Product Announcement

9000028 VENT, HYDROPHOBIC 1/4" NPT 100 MICRON 8000029 KIT, DRILL AND TAP FOR HYDROPHOBIC

9000028

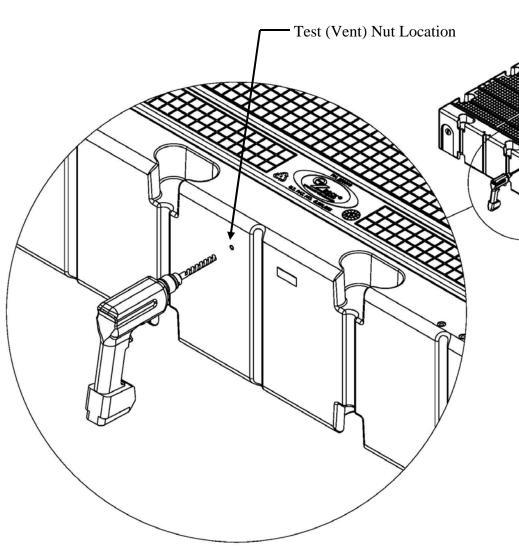
Introducing the new EZ Dock Hydrophobic vent (9000028). All future production of docks and ports will include one of these vents to replace the "open to atmosphere" vent. This new vent is designed to allow the dock/port sections to breath but will not allow water in pass through. The new vent will be factory installed in one of the spin weld areas. In addition these vents can be purchased to retro fit older dock sections in the field using only a drill. A Drill and Tap Kit is also available (9000029) and comes with a 7/16" drill bit and a 1/4" NPT tap (this TAP threads the 1/2" hole into which the vent is threaded).

- 1. Drill out the current 1/4"vent hole with a 7/16" drill.
- 2. Using the supplied tap (1/4"-18 NPT) tap. Tap should be used at low speed
- 3. Insert hydrophobic vent PN# 9000028) into tapped hole and tighten till flush with #3 Phillips screw driver
